**PROTERRA**

# TECHNICAL SERVICE BULLETIN

<b>ISSUE DATE:</b>	10-6-2021
<b>SERVICE BULLETIN SUBJECT:</b>	Ancillary Bay Battery Pack Ground Screw Replacement
<b>VINs or MODELS AFFECTED:</b>	Service Specified Buses
<b>COMPLETE BY:</b>	Next Service Opportunity
<b>SERVICE BULLETIN #:</b>	SC-21-174
<b>Labor Operation Code:</b>	HB45Z

## ANCILLARY BAY GROUND SCREW RETROFIT

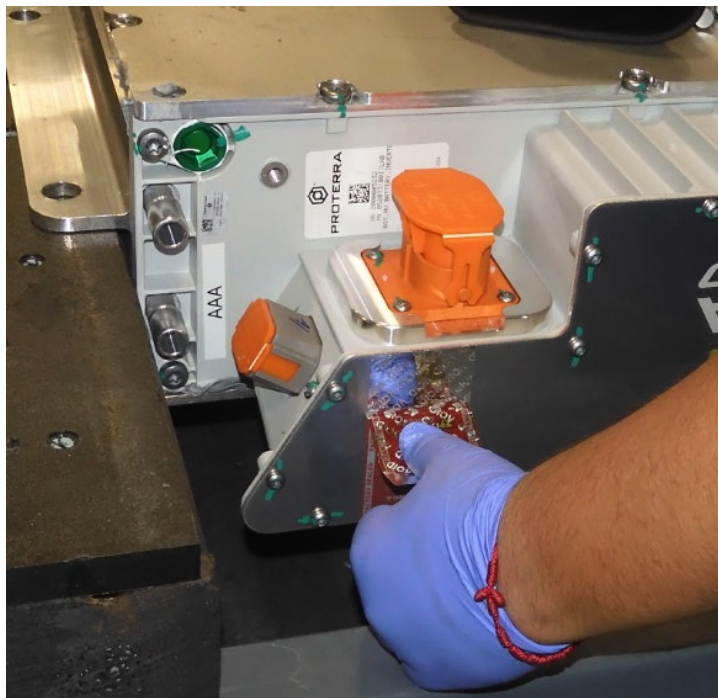
9. Using the calibrated Hioki RM3545 Resistance Meter, measure the resistance between the two points shown in the following photograph. Clean the areas with Shop Towels and Isopropyl Alcohol before beginning the measurement.

10. Make a note of the measured value. The value should decrease when the old Screw is replaced with the new Screw (022265).
11. Remove the Warranty Label (022363) from the Ancillary Bay Cover as shown in the following photograph.

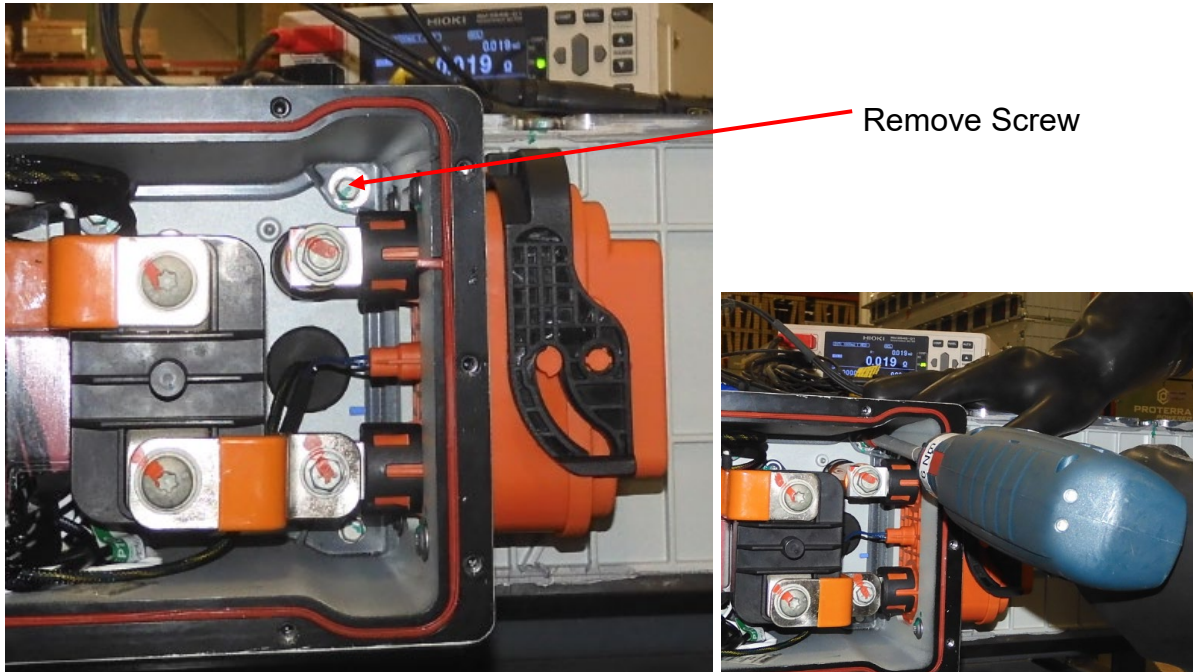
16. Using an 8mm Magnetic Insulated Nut Driver, remove the Screw in the corner of the Ancillary Bay nearest the MSD.

17. Using a T-25 Torx Driver, install the replacement Screw (022265) in place of the original that was removed.

18. Using a Calibrated Torque Wrench with a T-25 Torx Socket, **torque the fastener to 53 inch-pounds.**

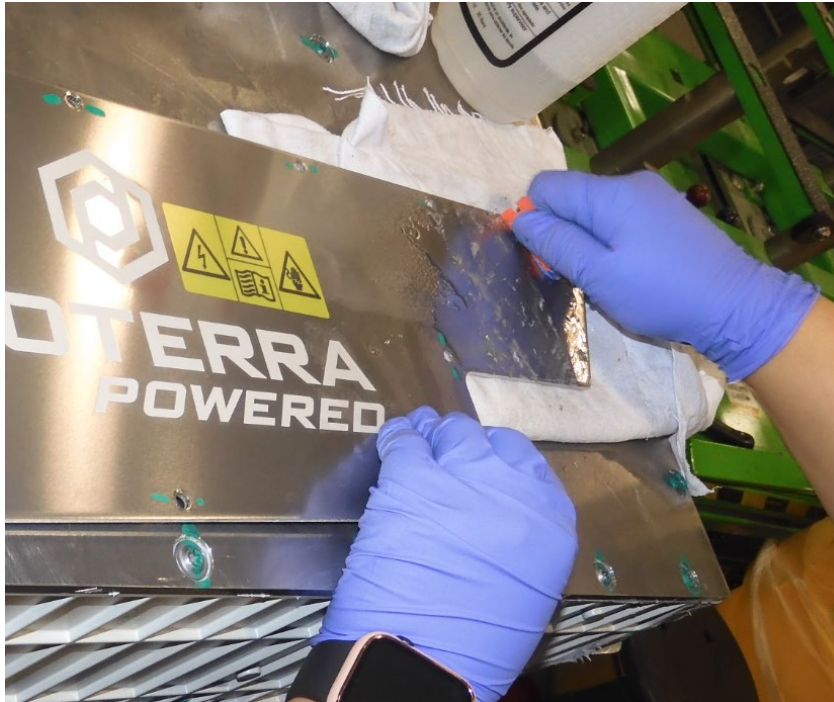
21. Using the calibrated Hioki RM3545 Resistance Meter, repeat the Resistance Measurement performed earlier.

22. Record the Resistance Measurement. The value should be 10 milliohms or less.
